**A Review on the Report by Bureau Veritas on**  
Investigation of distress in basement floor and terrace level overhead tanks of  
Army Welfare Housing Organisation “Chanderkunj Army Towers”  
at Silver Sand Island, Vytilla, Kochi, Kerala (November 2020)

**Review of the report by Bureau Veritas (dated Dec 3, 2020) for  
Chander Kunj Apartments, Silver Sand Island, Vytilla, Kochi**

**Table 1: Specific comments on inferences in BV Report**

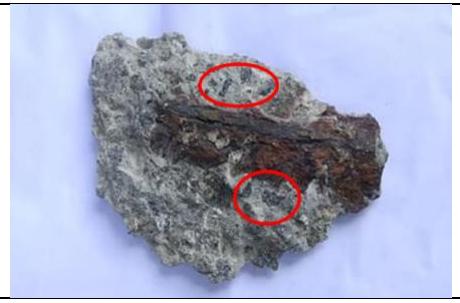
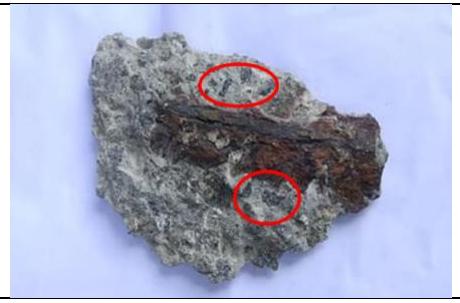
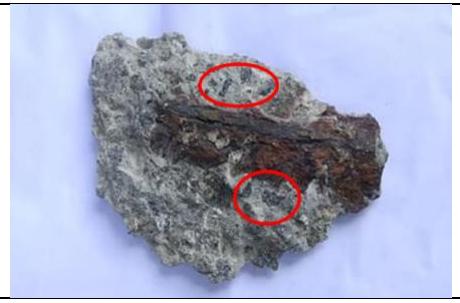
Table 1 provides my responses/suggestions against all the inferences in the BV Report. Also, the recommendations made in the BV Report are inadequate to achieve a service life of multiple decades with minimal maintenance and without major/repeated repairs. **Please arrange to conduct more tests and data analysis as suggested in Table 1 and revise the Sections D, E, F, and G of the BV Report.** Also, the collected data should be assessed in a quantitative manner, wherever possible. The submitted BV report do not comment on the corrosion and chloride conditions of the members that exhibited and are exhibiting corrosion/cracking. The revised report must reflect these. Note that Item 6 in Table 1 shows that the chloride contents (from the tests conducted at IIT Madras) in the concrete samples supplied is higher than the allowable chloride content of  $0.6 \text{ kg/m}^3$  (as per IS 456).
